**CITY OF ESSEX JUNCTION
DEVELOPMENT REVIEW BOARD
PUBLIC HEARING AGENDA**

**CITY OF ESSEX JUNCTION
DEVELOPMENT REVIEW BOARD
MINUTES OF MEETING
JULY 17, 2025
DRAFT**

To: Development Review Board
From: Michael Giguere, City Planner
Date: August 21st, 2025
Subject: Design review for the construction of a new single-family home at 40 Maple Street by Ron Bushey, owner.
File: SP# 6.2025

To: Development Review Board
From: Michael Giguere, City Planner
Date: August 21st, 2025
Subject: Conditional use review for the addition of an exterior propane gas pump, design review, and site plan review for Tractor Supply Company at 70 Pearl Street in the Transit-Oriented Development (TOD) district by Cathy West, Parkway C&A, LP and Brandon Kubik c/o Pulley Studios, Inc. on behalf of Shawn Handy c/o Handy's Hotel & Rentals LLC, owner.
File: SP# 7.2025

AS1.00

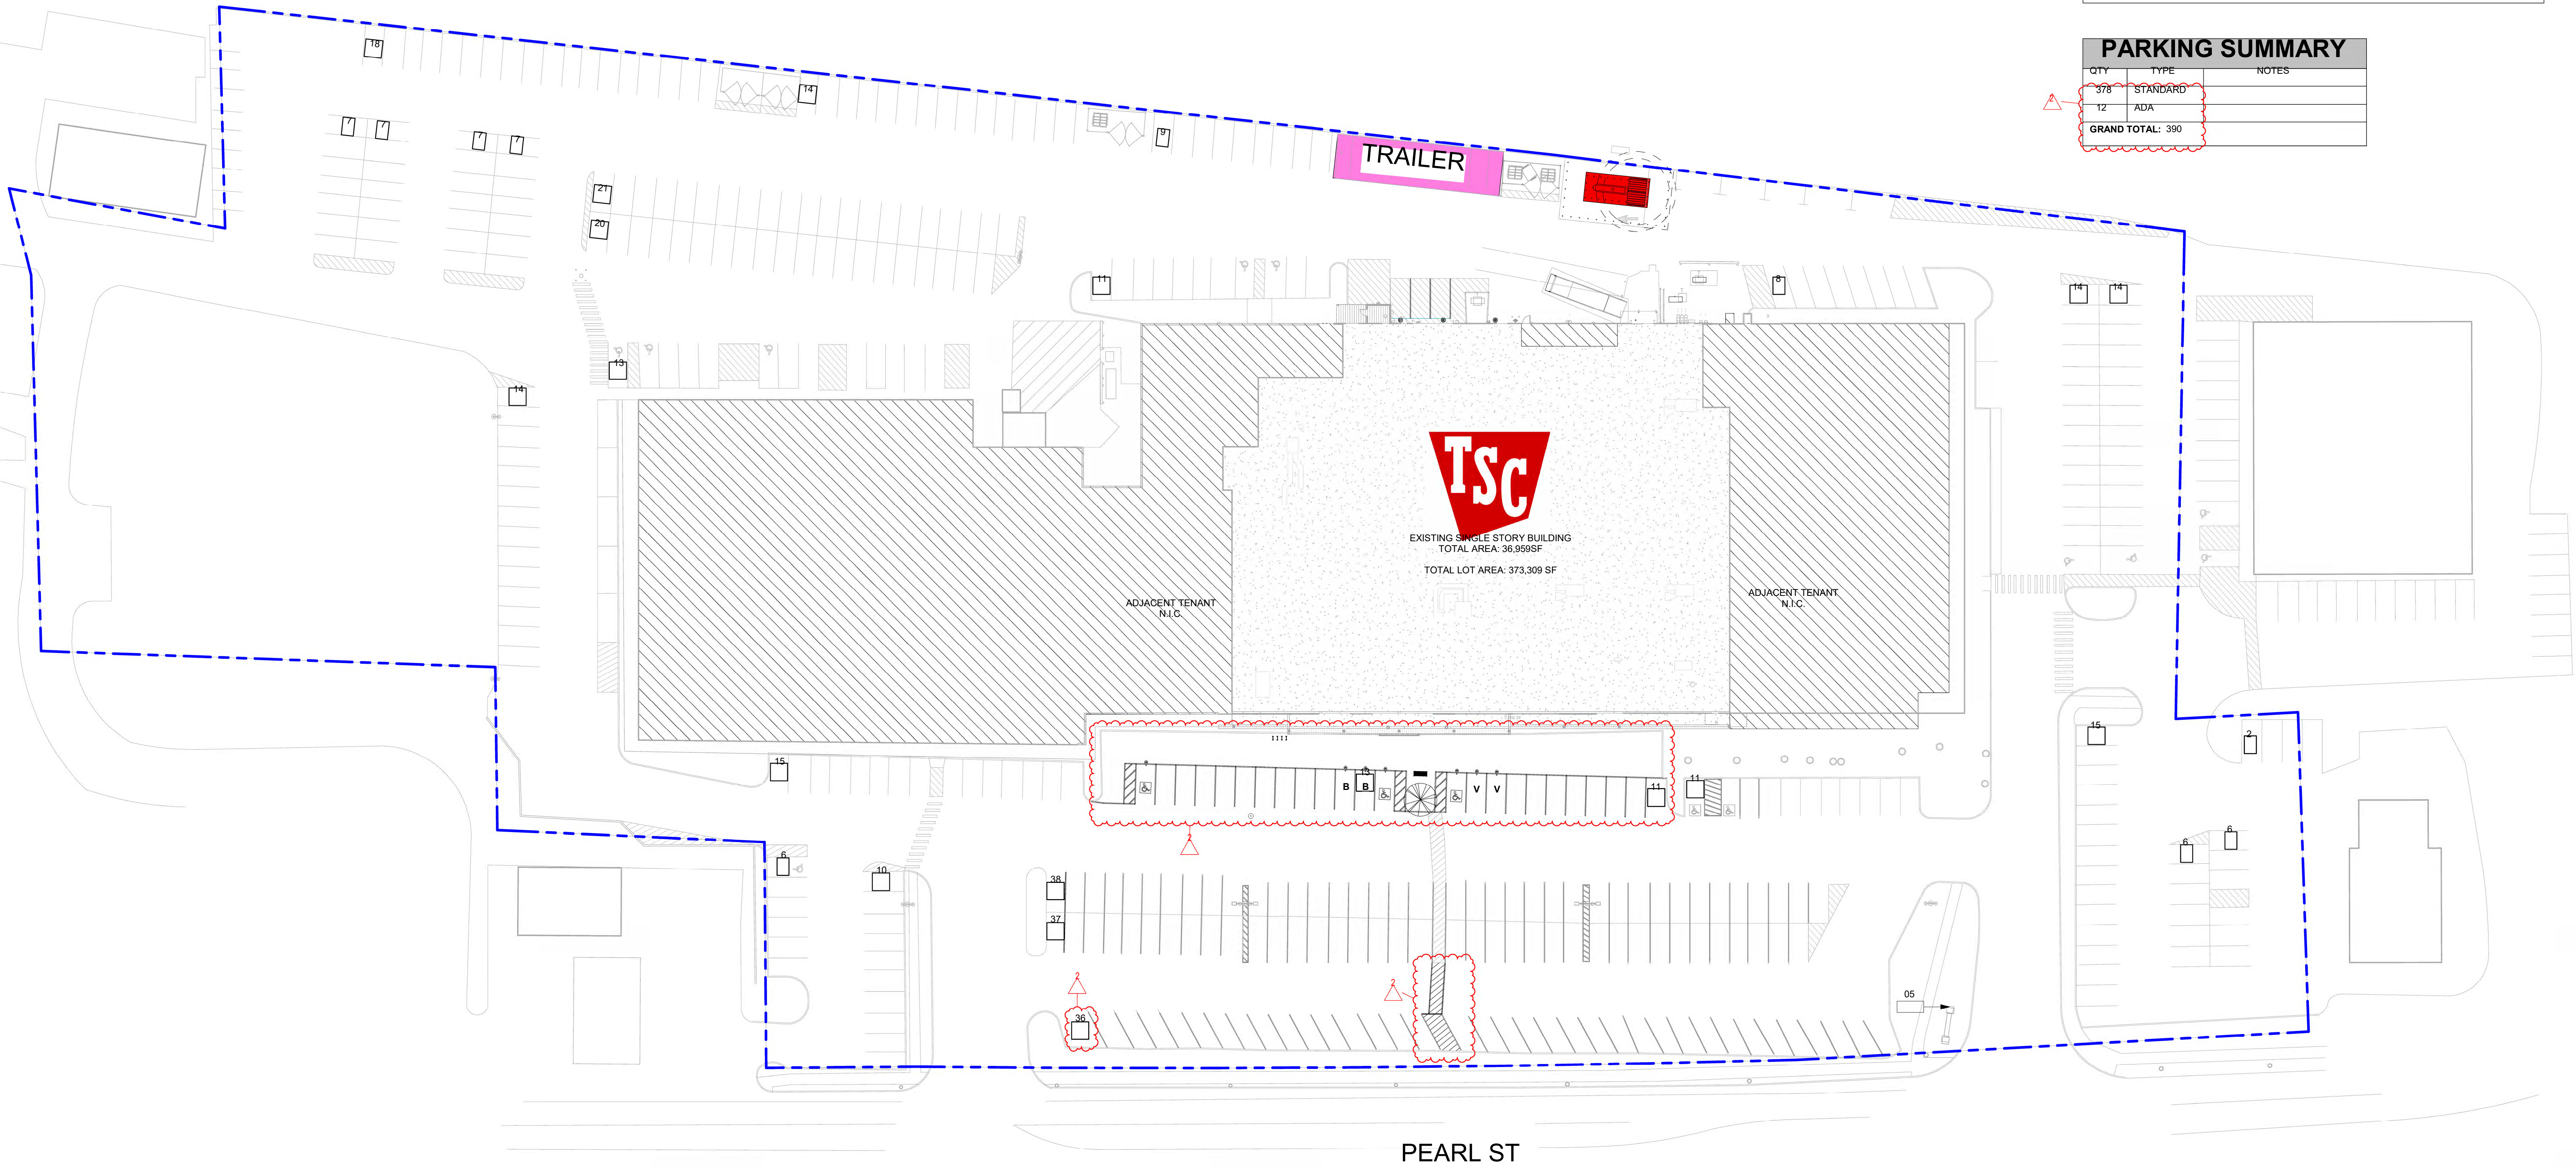
1. Looking at the “Trailer” and propane dispensing areas, Sheet AS1.00 (Architectural Site Plan) disagrees slightly with AS1.00A (Overall Site Plan). The applicant should clarify which sheet is correct.

6. Sheet A7.02 includes details on both a 6’ fence and a 20’ fence but I can’t seem to find them on the site plan. Where are these proposed to be installed?

Response: Sheet AS1.00 has been revised to match the overall site plan. Please see sheet AS1.00

Response: Added Shade tree and bench, refer to Site Plan AS1.00.

Response: (4) Inverted-U bike racks have been added. Please see AS1.00

1. **AS1.00 – ARCHITECTURAL SITE PLAN**
 - a. Revised Trailer location to match the overall site plan.
 - b. Re-stripped parking area in front of store to align with adjacent tenants.
 - c. Added (4) inverted-U bike racks in front of store.
2. **A7.02 – LP-GAS PLAN AND DETAILS**
 - a. Removed Fence Details.
3. **F1 – FIXTURE PLAN**
 - a. Added Fixture Plan to show display areas with dimensions.

F1

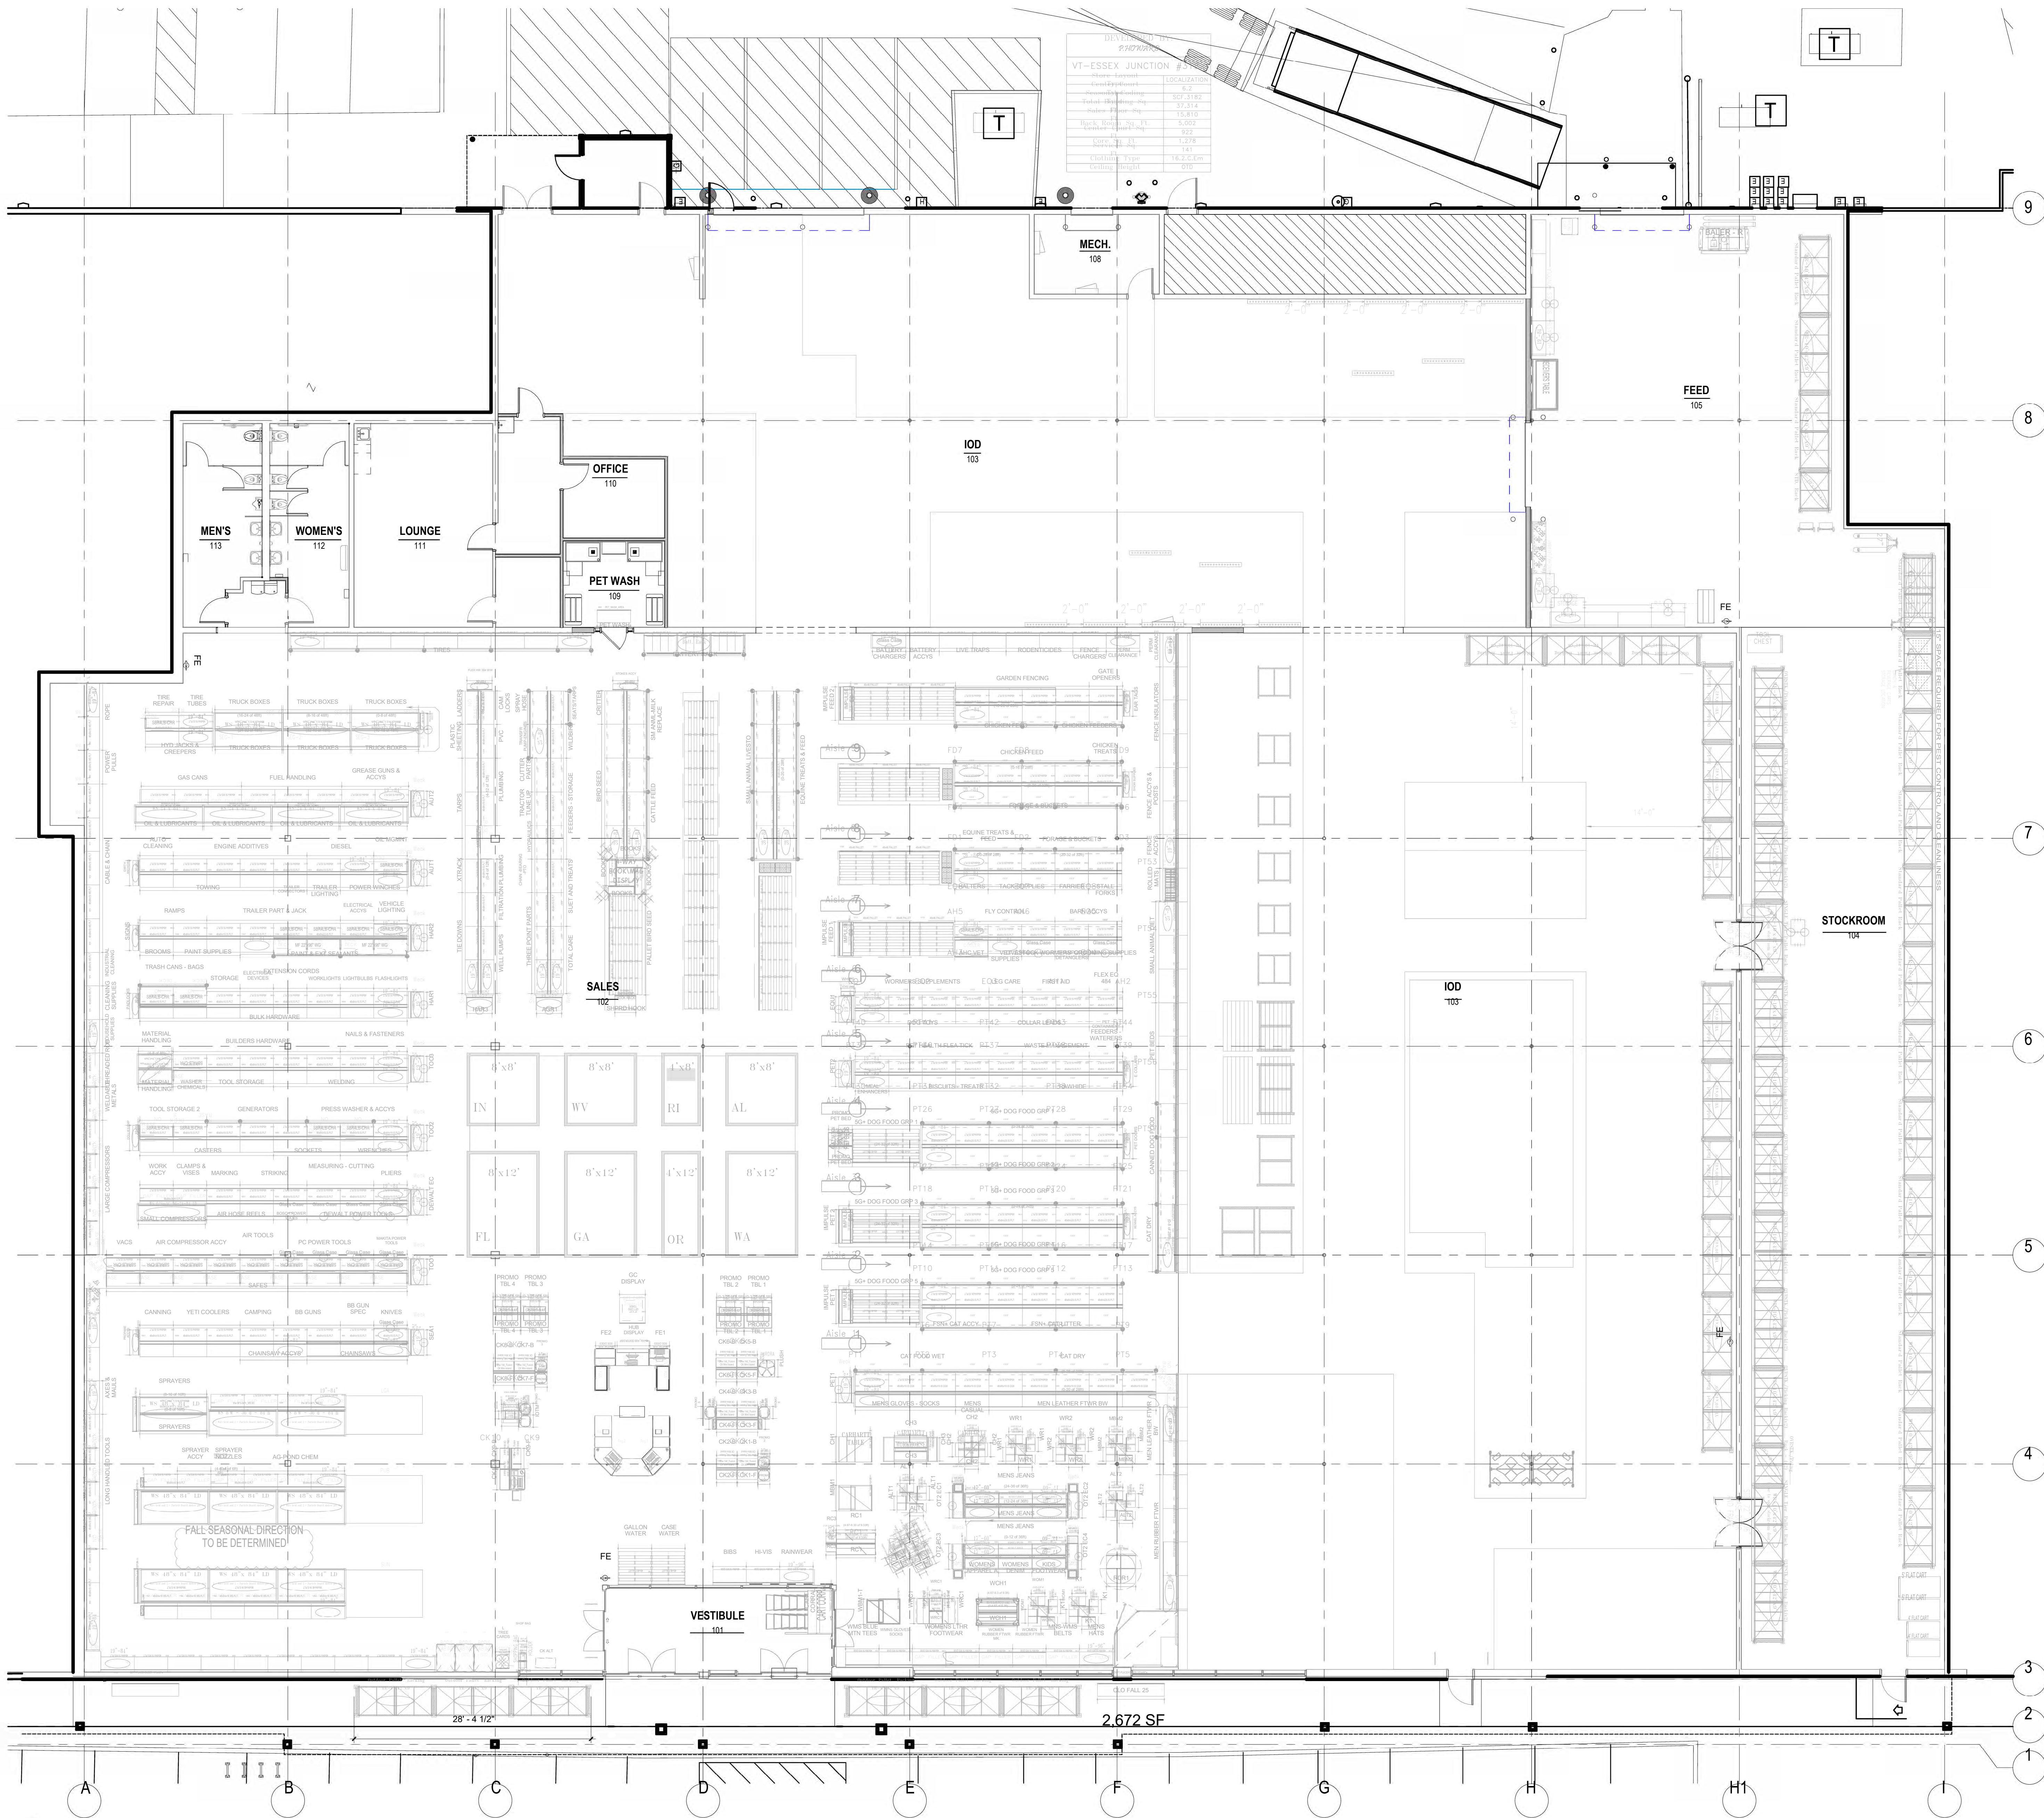
Sidewalk Display – Refer to Sheet F1 (260sf)

Response: Sheet F1 – FIXTURE PLAN has been added to show sidewalk display areas with dimensions. The site plan has been revised as suggested. Please see sheets AS1.00 and F1.
